DRAWING AMENDMENTS

REMARKS

FIG. 1

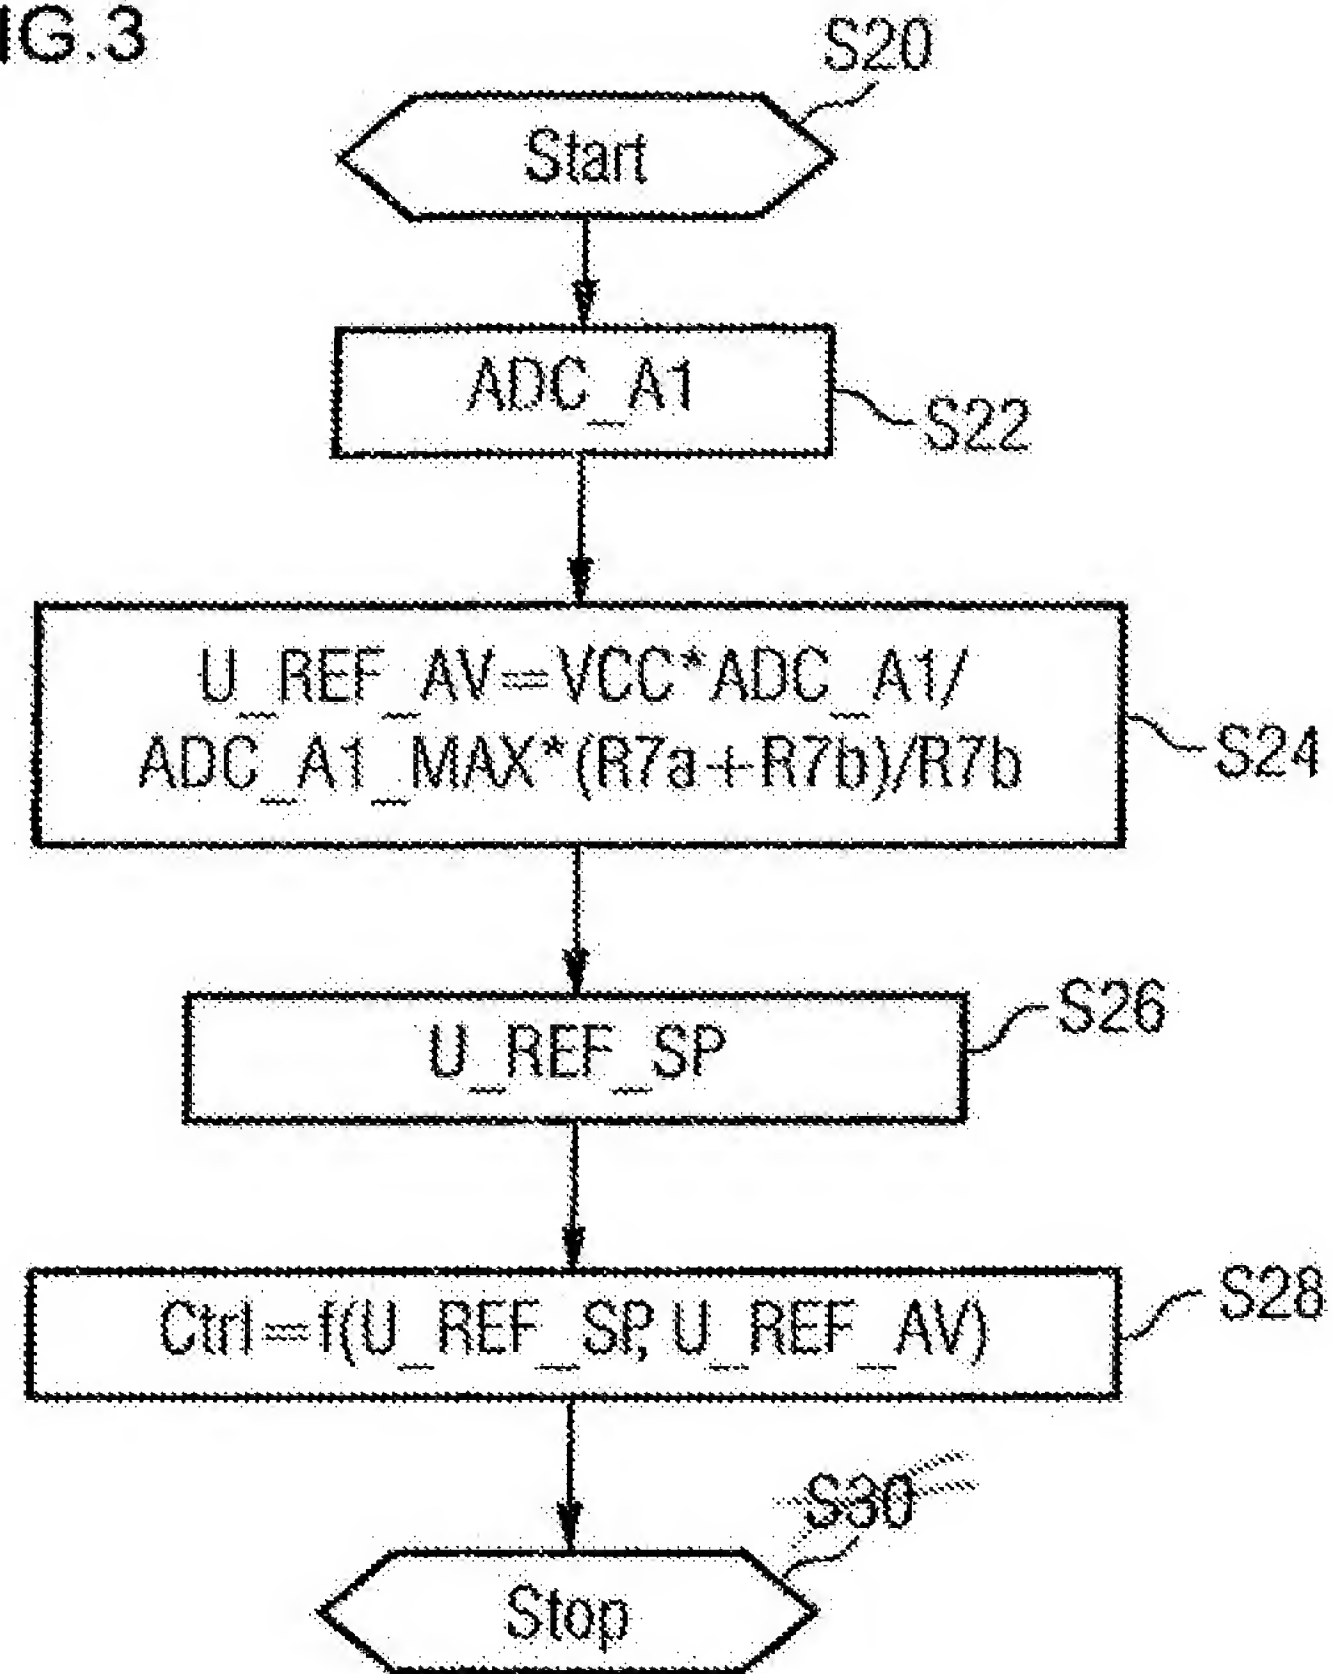
Under the heading "Drawings" on page 2 of the above-identified Office Action, the Examiner objected to the drawings because they did not include reference number 31 associated with the analog to digital converter described in the specification.

Reference numeral 31 has been associated with the analog to digital converter in Fig. 1.
